**NATIONAL RAILROAD PASSENGER CORPORATION
NORTHEAST CORRIDOR
NEW YORK - WASHINGTON
SUMMARY BULLETIN ORDER No. NYW1-20SUM
Effective 12:01 AM, Monday, September 1, 2025**

INDEX OF RULE / SI CHANGES OR MODIFICATIONS CONTAINED IN THIS BULLETIN ORDER

- c) 45WC high color light interlocking signal on Signal Bridge 16 has been placed in service. This signal governs westbound movement on the portion of Harold Interlocking extending between the 2254 Switch and the 4145 Switch.

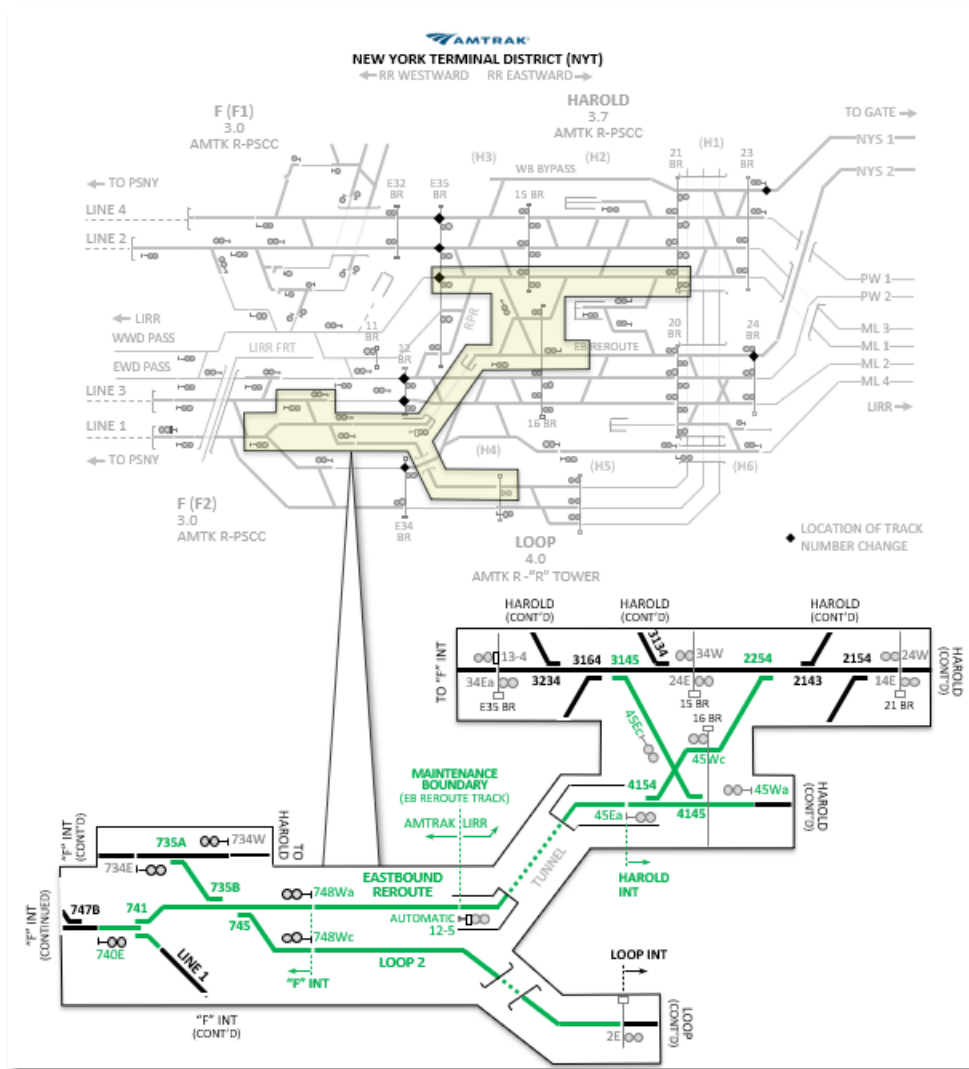
The signal is capable of displaying the following aspects:

- Rule 283- Medium Clear
- Rule 286- Medium Approach
- Rule 290- Restricting
- Rule 292- Stop Signal

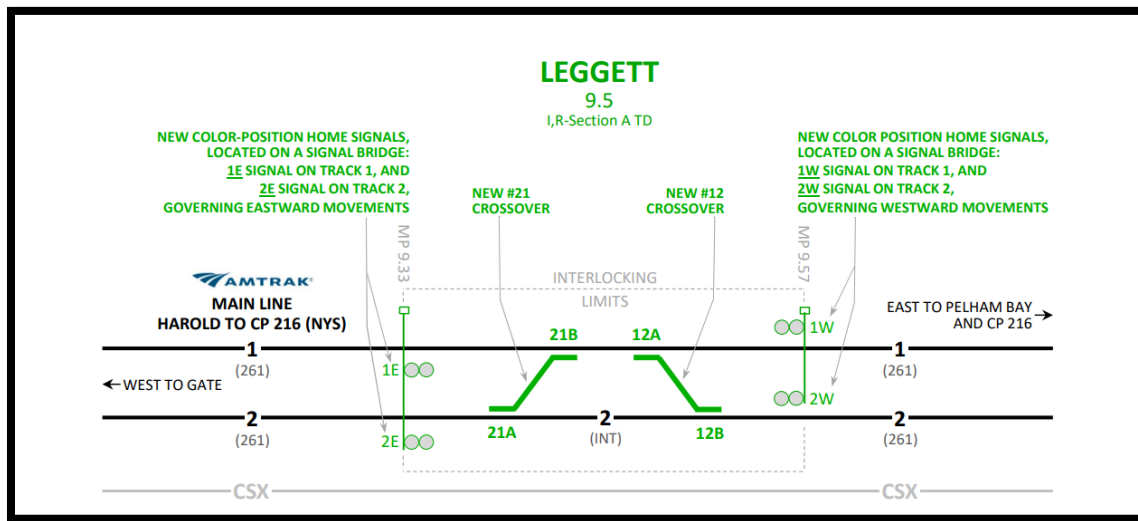
Signals 90-1 and 90-2 are removed from service and bagged.

The existing automatic signals (90-1 and 90-2) governing eastward movement on No. 1 & No. 2 Trks at MP 9.09 are bagged and removed from service.

2. Platform 3**08/05/24**

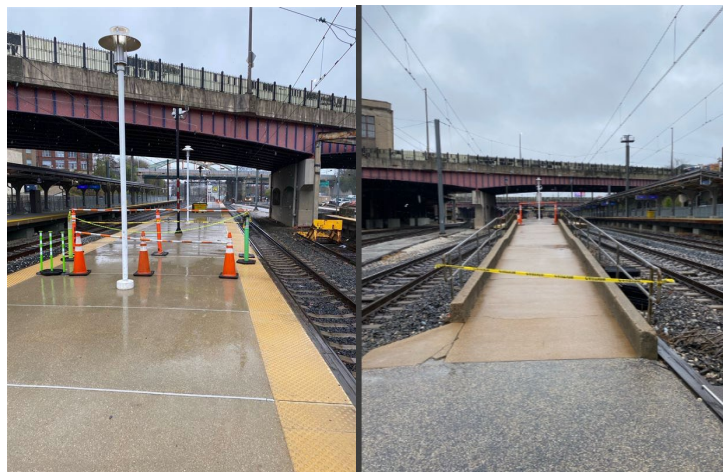
The south end of platform 3 located between No. 4 and No. 5 track is out service from a barricade erected 168 feet north of the south end of the platform. *The out of service portion is accessible for Amtrak employees and contractors only.*

2. AC Motor Stop Signs

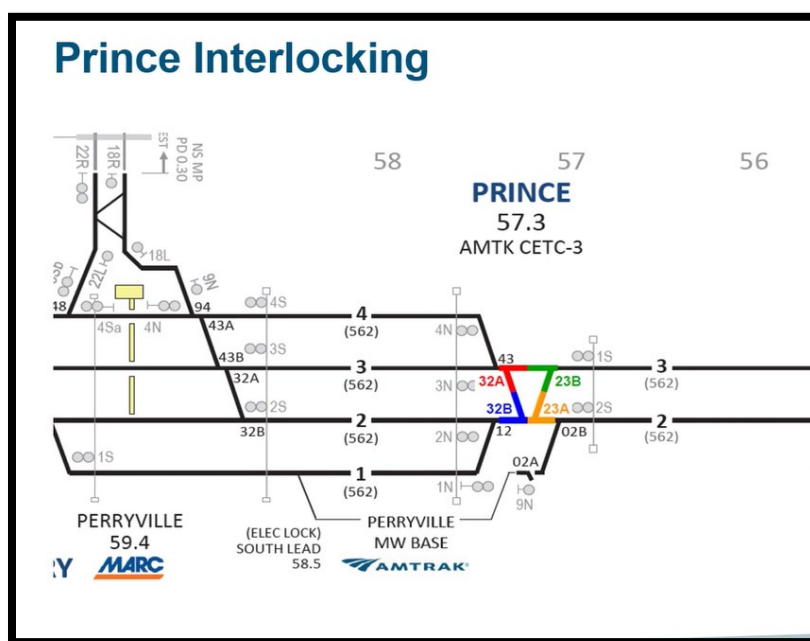
- AC Motor Stop Signs have been erected on No.3 track and located 175 feet south of the No. 43 switch at Paul (31 feet north Pole D1313) and 109 feet north of the No. 13 switch at Charles (Pole D1325).
- AC Motor Stop Signs have been erected on No. 1 track and located 956 feet south of the No. 61 switch at Paul (Pole D1311) and 216 feet north of the No. 13 switch at Charles (Pole D1324).

J. 594-W1. Entering PTC Track

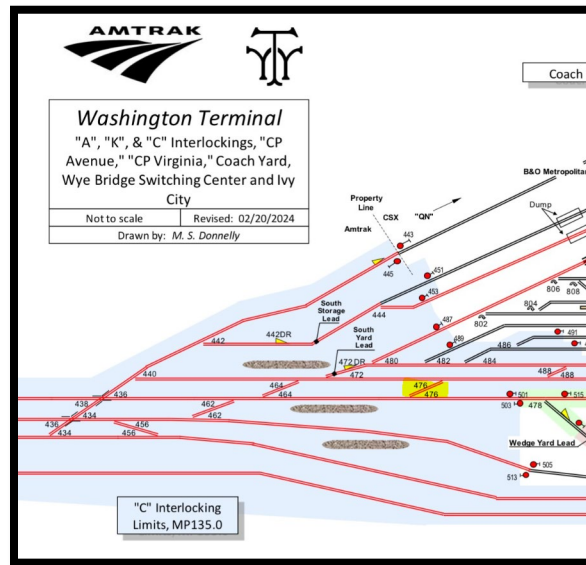
594-W1 is modified. Trains entering I-ETMS territory must initialize I-ETMS and select track at the locations identified. Washington Coach Yard and Wedge Yard instructions have been added.

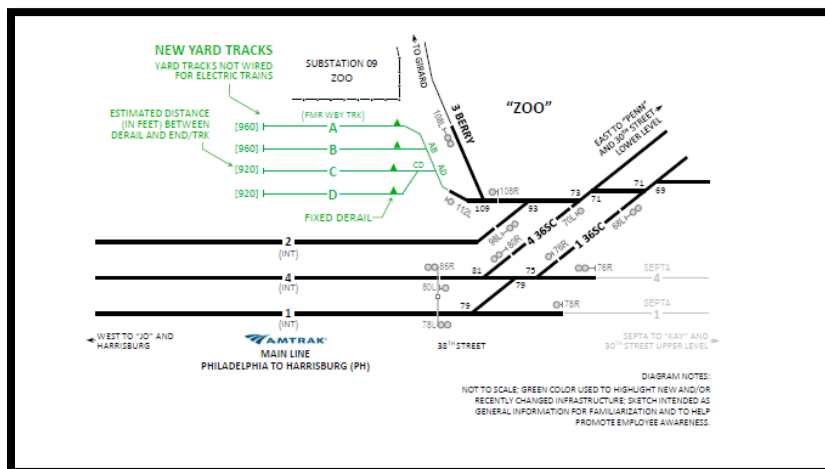
Zoo Yard is new, Zoo Yard is located within Zoo Interlocking at MP 2.3

Previous Track Designation	New Track Designation	Total Length
WBY	A Track	960 Feet
	B Track	960 Feet
	C Track	920 Feet
	D Track	920 Feet

H. PC: Caln Int

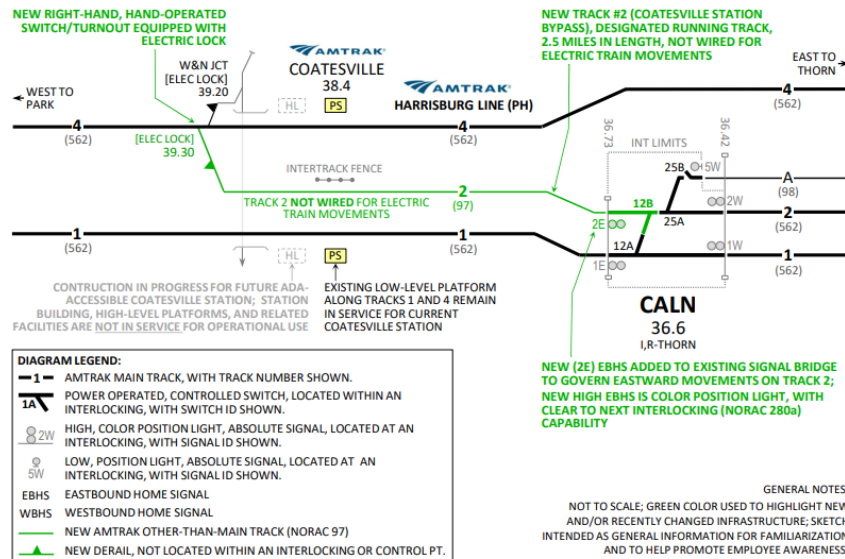
Caln Int map is modified. Letter A Trk Movement is a Track Not Governed by ABS, DCS or Interlocking Rules (Rule 98). The 2E signal is modified from Clear Block to Clear to the Next Interlocking.

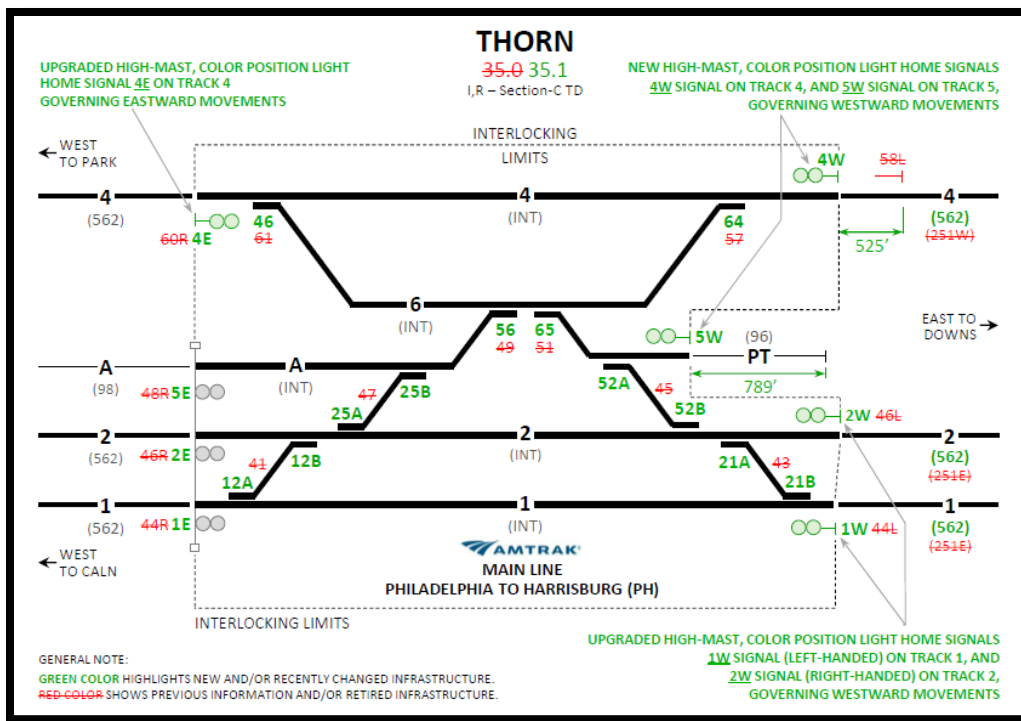
- **5E Signal**
The 48R signal is renamed the 5E signal. The 5E signal is capable of displaying the following aspects:
 - Rule 288- Slow Approach
 - Rule 290- Restricting

- Rule 291- Stop and Proceed
 - Rule 292- Stop
